# **Intel<sup>®</sup> Ethernet Controller 82571EB/82572EI/82571GB/ 82571GI Specification Update**

**Networking Division (ND)**

### 3. System-Level EMI Test Can Be Affected by 490MHz Harmonic Seen In 10Base-T Waveform Spectrum.

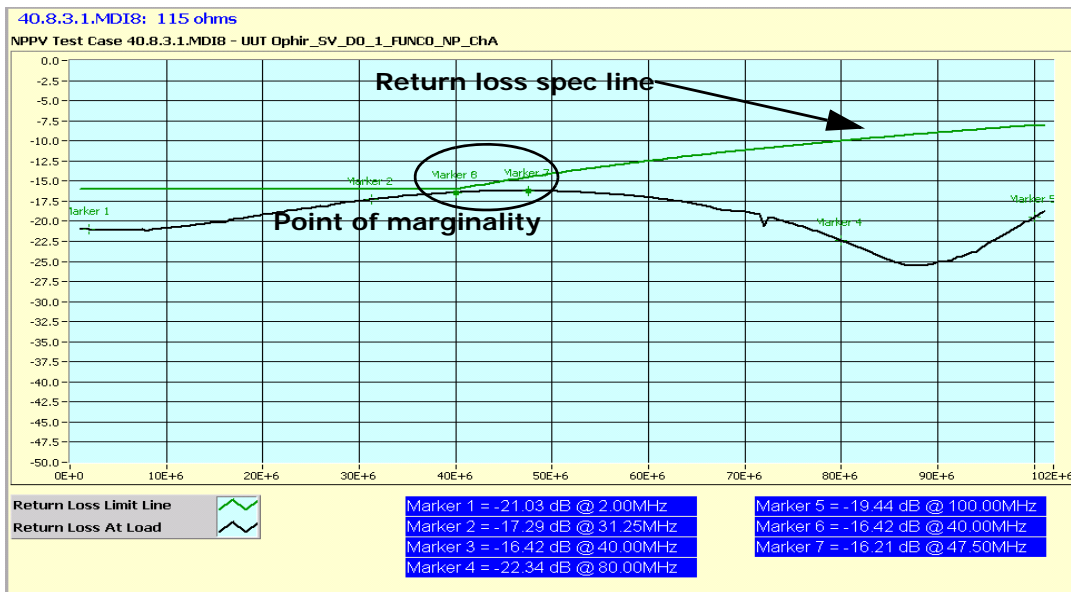
This is not a violation of any IEEE specification. This harmonic may, however, contribute to EMI (electro-magnetic interference) in a system-level check at this frequency.

There is no impact on system-level performance.

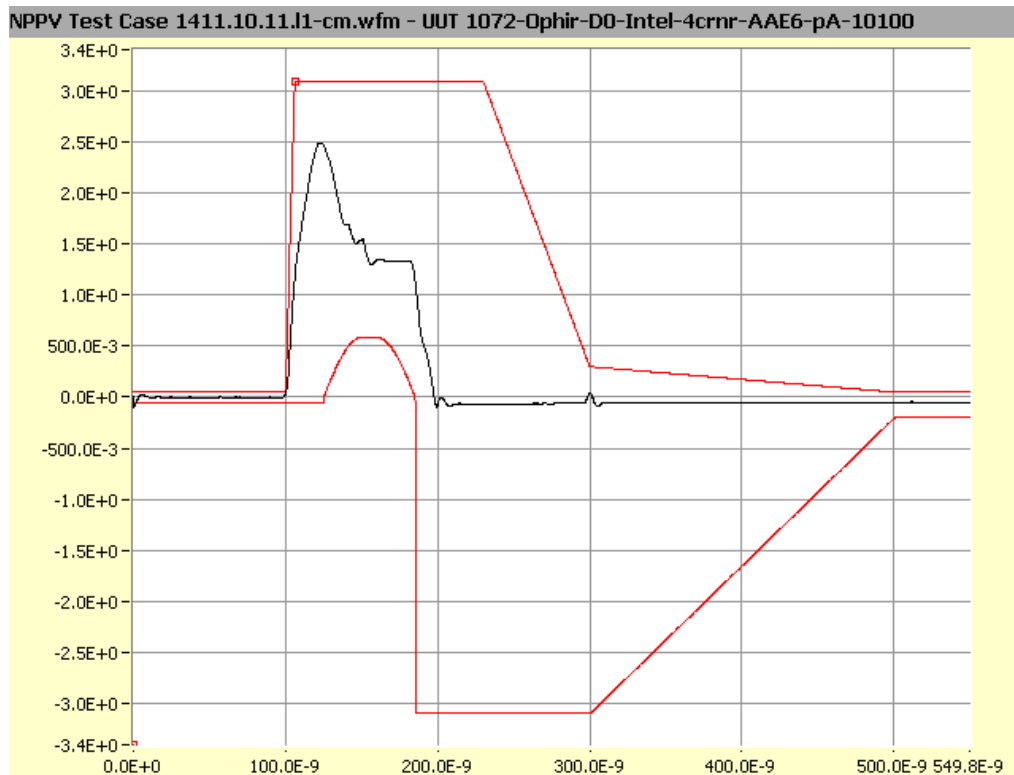
The BMC should not transmit with an IPG lower than 30usec.
